ADDENDUM NO. 3

Project:	New Joplin Library
	Site Landscape Construction Documents
	Volume 2 of 2
Cliet:	City of Joplin
EDA PROJECT#:	05-79-05345
Date:	November 20, 2015
Subject:	Landscape Architecture Addendum No. 3

FENCE TYPE 2 EASTERN SITE BORDER (Contractor Option)

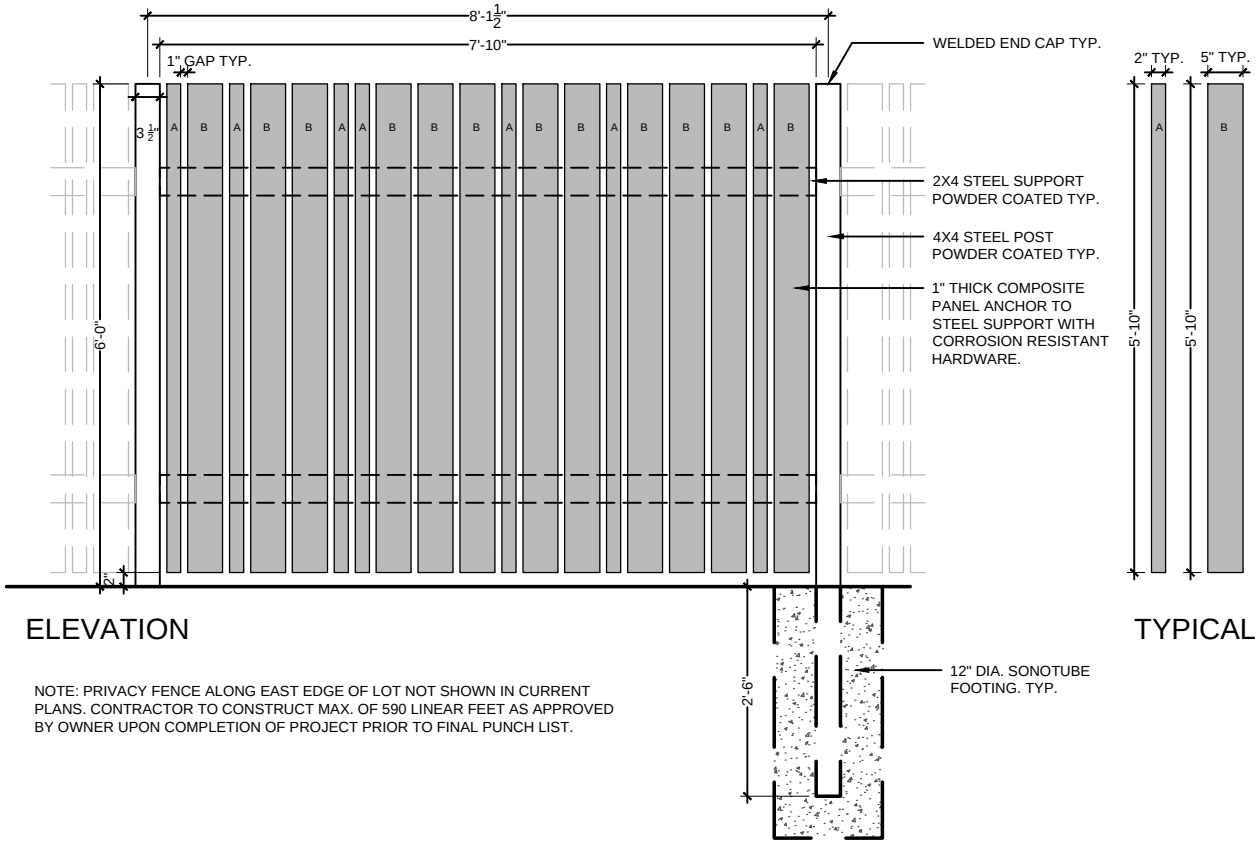
Relating to Volume 2 of 2 – Sheet L7-14 – Detail 2 Fence Type 2 Eastern Site Border

It has been brought to the design team's teams attention that 11" wide x 1" thick composite material is difficult to source. The following drawing depicts a contractor's option to bid either Option 1 as depicted in the drawings set or the attached drawing (Option 2).

11" x 1" thick composit material was eliminated from previous design in this option. Contractors may elect to omit "panel size C" in original detail design and replace ea. "C panel" with (2) "panel size B" components as shown in this option.

The 11" panel has been eliminated and replaced with (2) 5" panels for each occurrence. This change does not require in any way that the contractors must bid or construct this new option is simply offers the opportunity if desired. The contractors are not required to specify which option they are bidding at this time.
